**FINAL
MY2 (2023) MONITORING REPORT**

LAUREL SPRINGS STREAM AND WETLAND MITIGATION SITE

Response to DMS Comments – MY2 (2023)

Laurel Springs Stream and Wetland Mitigation Site
Avery County, North Carolina, French Broad River Basin: Cataloging Unit 06010108
DMS Project No. 100122
Full Delivery Contract No. 7890
DMS RFP No. 16-007725 (issued 11/13/18)
USACE Action ID No. SAW-2019-00835
DWR Project No. 2019-0865

Figure 1. Current Conditions Plan View

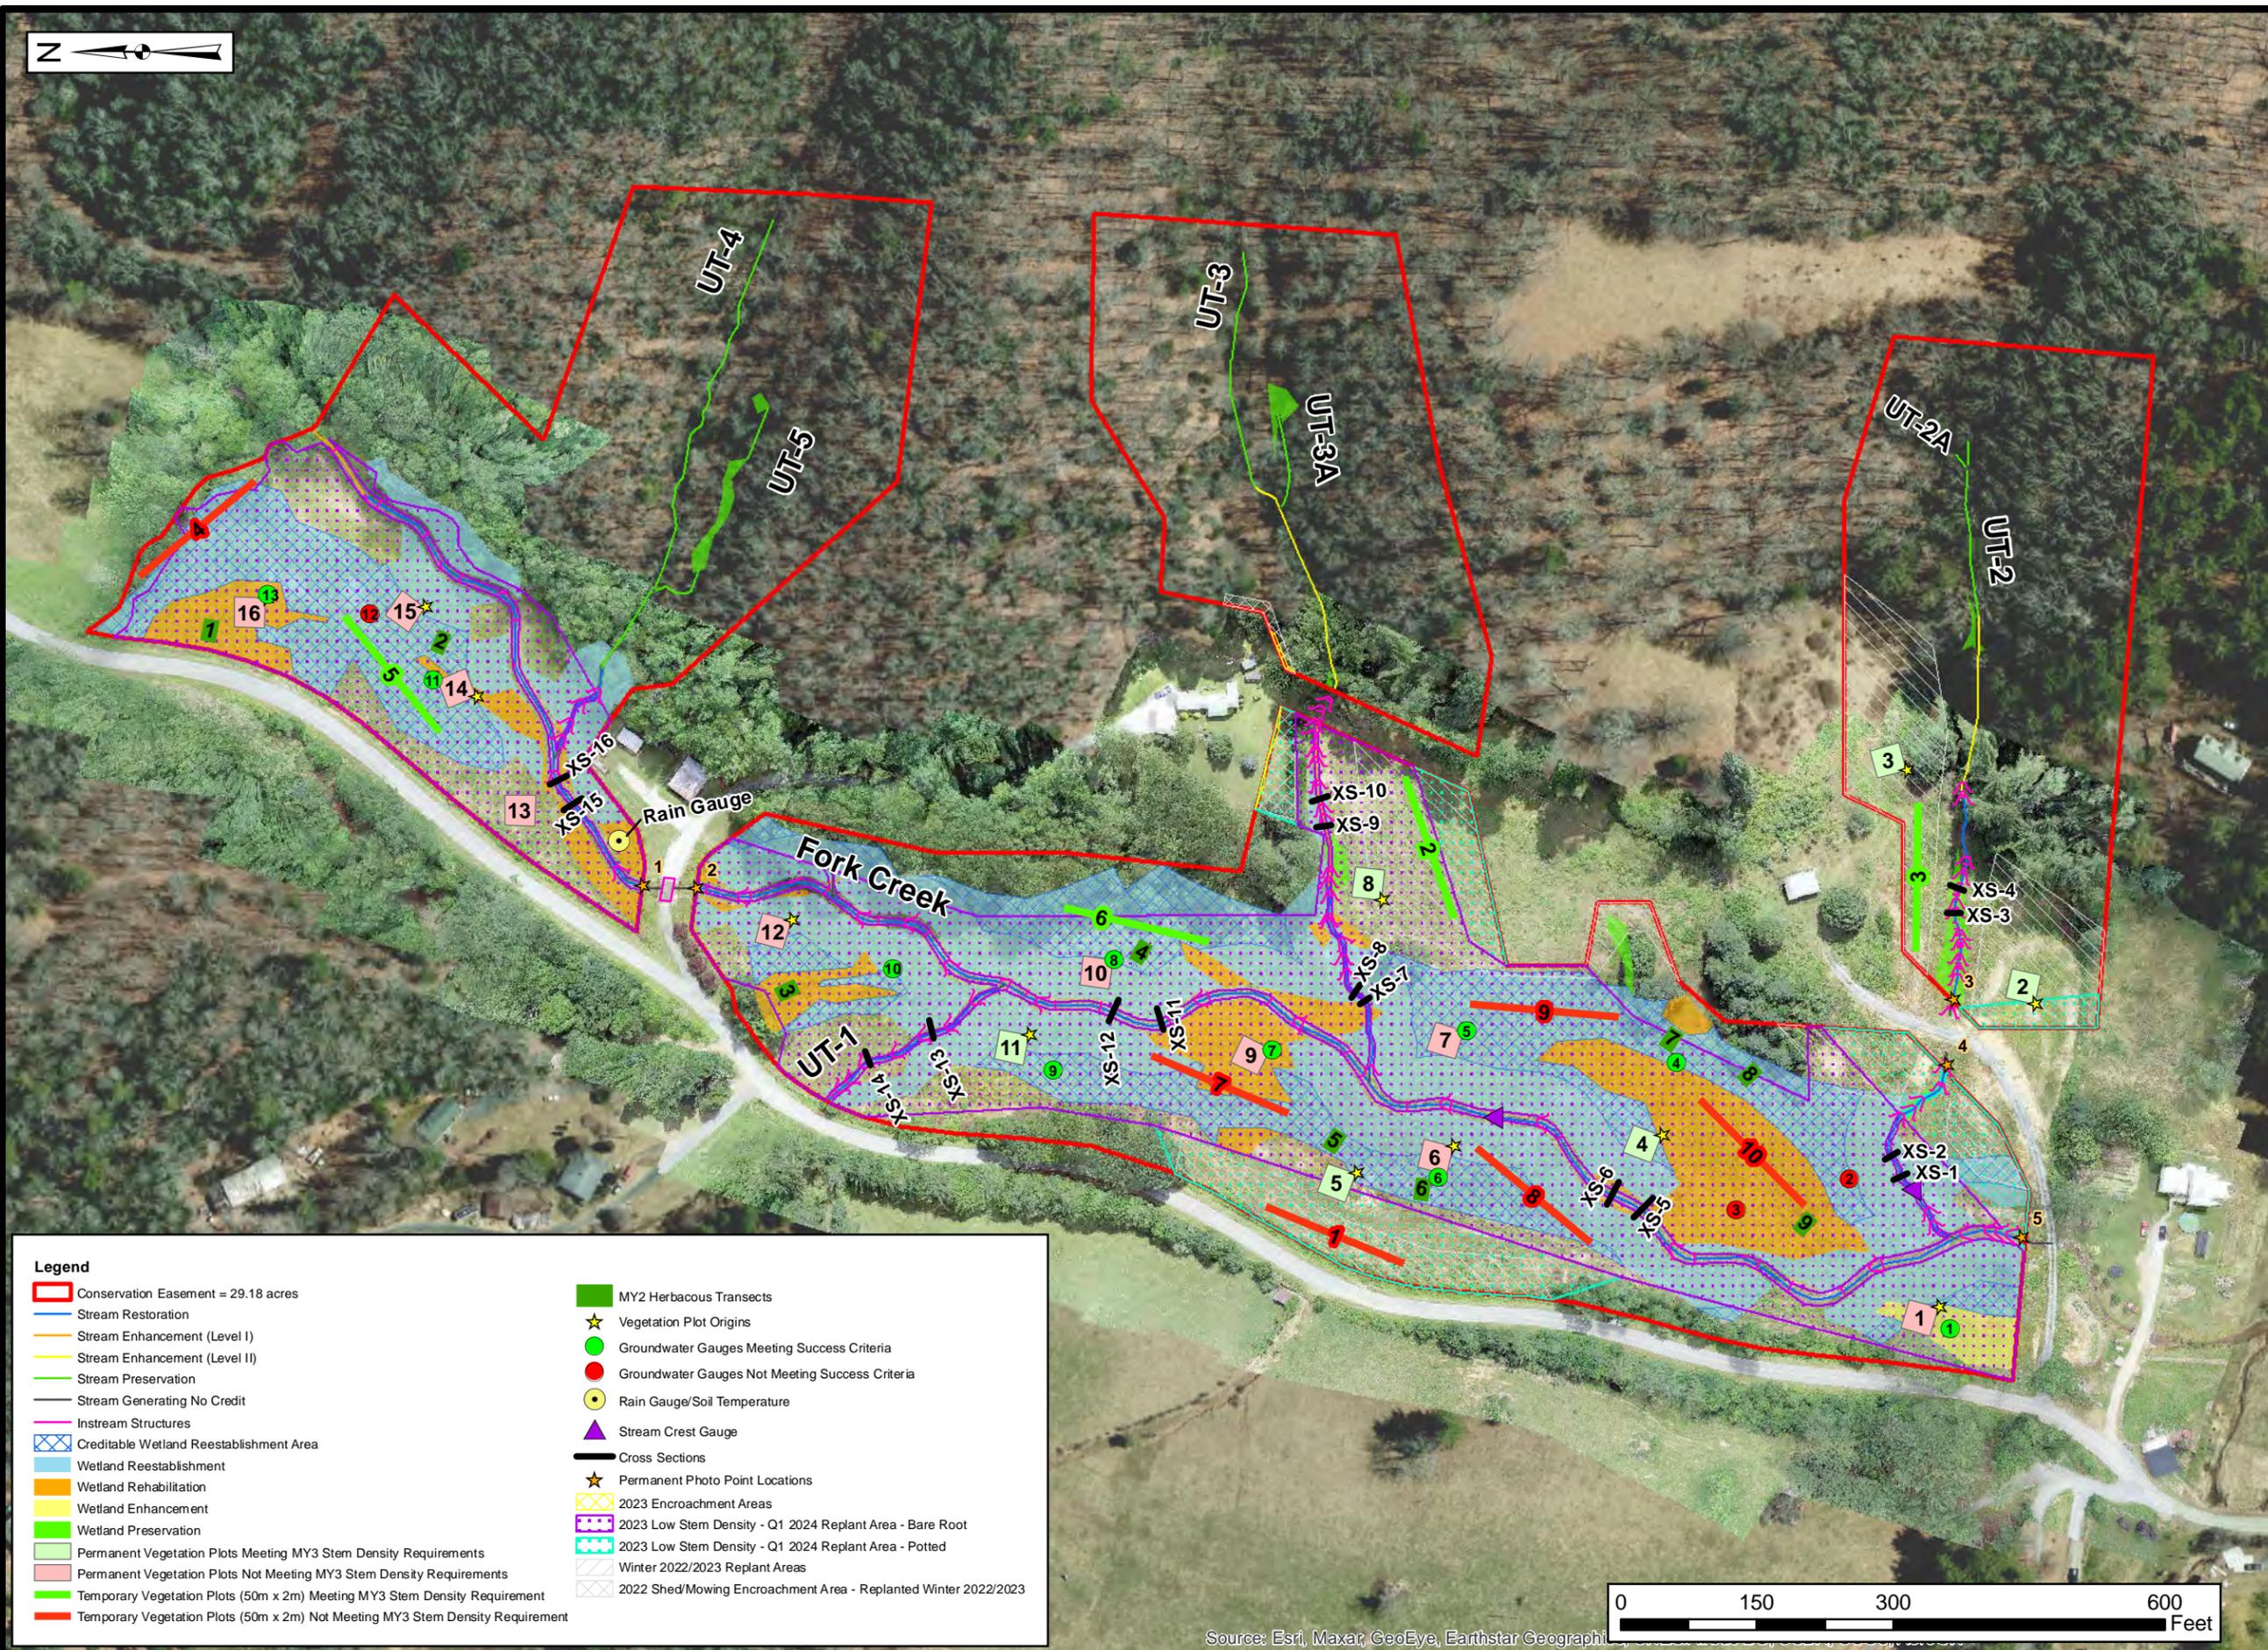
Response: A discussion of the 2023 encroachment was added to Section 3.4.
10. CCPV Map (Figure 1) and Asset Map (Figure 2): The CCPV & Asset maps are not georeferenced; please provide georeferenced maps with the revised deliverable.

Response: Figures 1 and 2 were re-exported to include georeferenced properties. These have been included in the final digital submittal.
11. Table 5. Visual Vegetation Assessment & CCPV Maps: Please update the table and CCPV maps as encroachment was observed during DMS’s 10/18/23 property boundary inspection. Please confirm that the invasives reported in the project monitoring summary are minimal and below the 0.10-acre mapping threshold. If above the mapping threshold, they should be reported in the table and CCPV sheets.

Response: Table 5 and the CCPV were updated to include encroachment observed during the 10/18/23 DMS boundary inspection. The invasives treatments that occurred on 6/28/23 and 9/19/23 were spot treatments of areas well below the 0.10-acre mapping threshold.

Laurel Springs Site
MY2 (2023) Vegetation Monitoring Photographs (taken September 21, 2023)

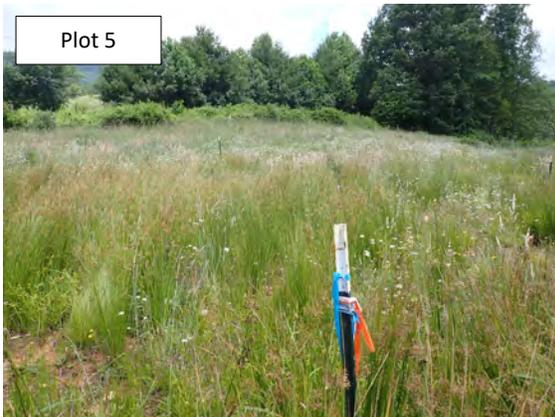
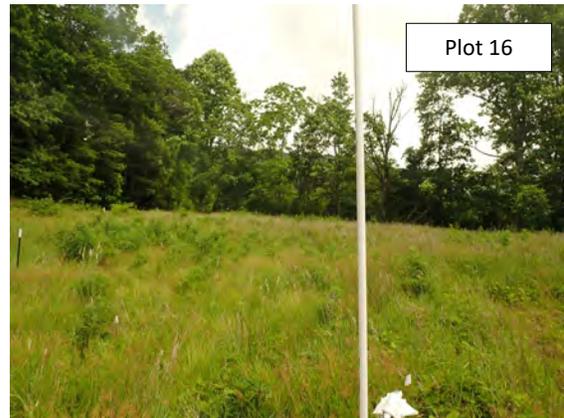
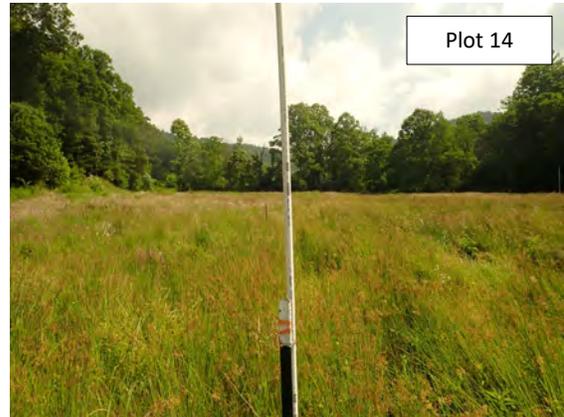
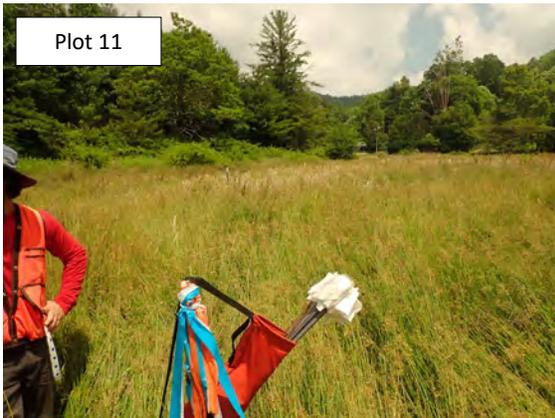
12. Laurel Springs MY2 (2023) Photo Logs (vegetation plots): Please provide dates that the photos were taken. Are the transect photos from the temporary vegetation plots or the herbaceous plots?

Response: The date the plot photos were taken (September 21, 2023) was added to the plot photo log header. The transect photos are from the temporary (woody) vegetation plots.

Laurel Springs Fork Creek Crest Gauge (2023 Data)

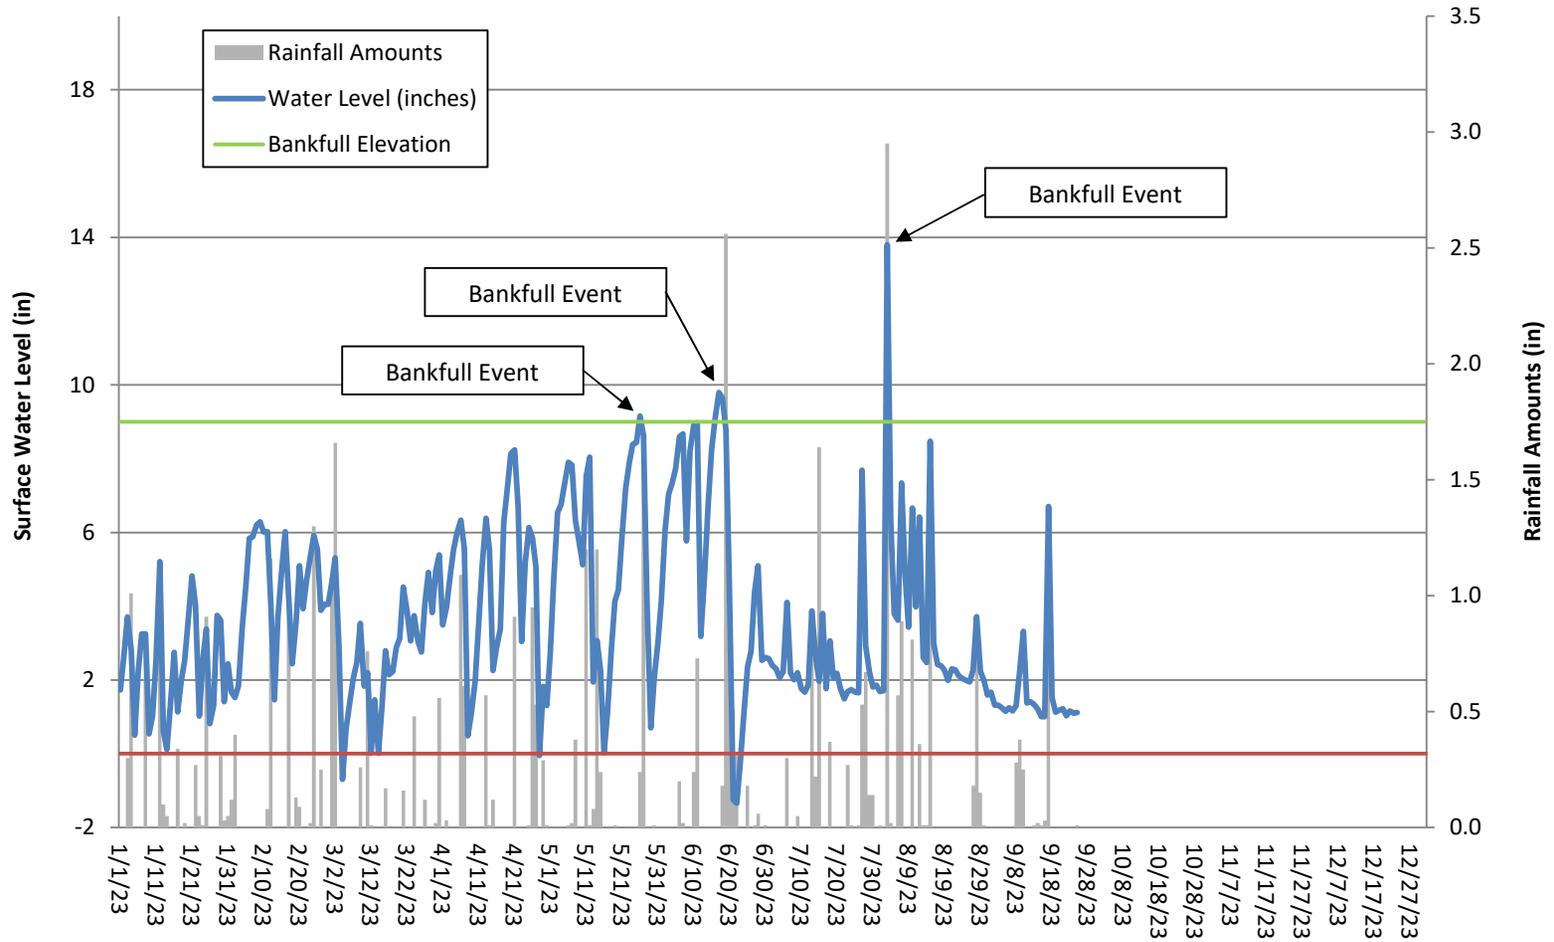
13. Laurel Springs Fork Creek Crest Gauge (2023 Data): Please provide a graph legend and include the bankfull elevation line.
Response: The bankfull elevation line was added to the crest gauge graph, and a legend was provided.

Figure D1: Laurel Springs
30-70 Percentile Graph for Rainfall
30-70th percentile data from WETS Station: Banner Elk, NC

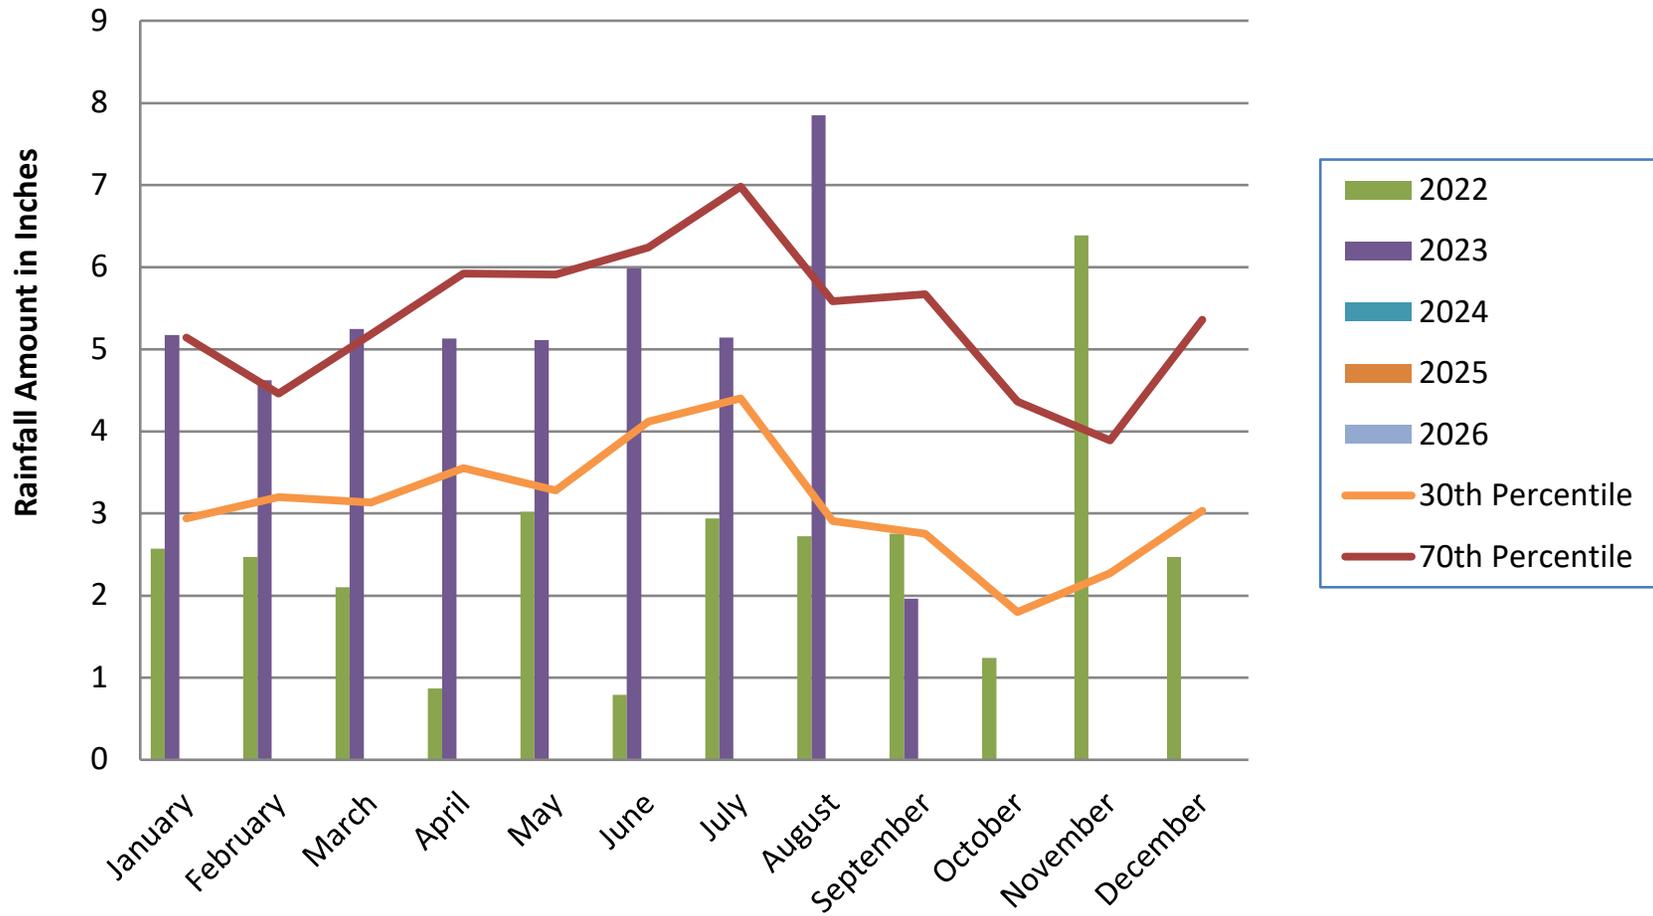
Response: Brackets were added to the maximum consecutive days for each gauge.
17. Appendix D - Figure D1: Please QAQC the rain data; Swamp Grape project was listed in the raw data files. Please make sure the rain data applicable to Laurel Springs is reported.

Response: The rain data was confirmed to be from an onsite gauge at Laurel Springs. The reference to Swamp Grape was mistakenly carried over from an older template. It has been corrected.
